#73892 - Durango DESC410R Front A-arms

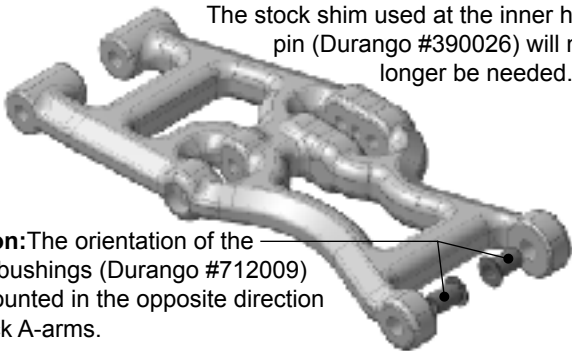
The stock shim used at the inner hinge pin (Durango #390026) will no longer be needed.

Caution: The orientation of the noted bushings (Durango #712009) are mounted in the opposite direction of stock A-arms.
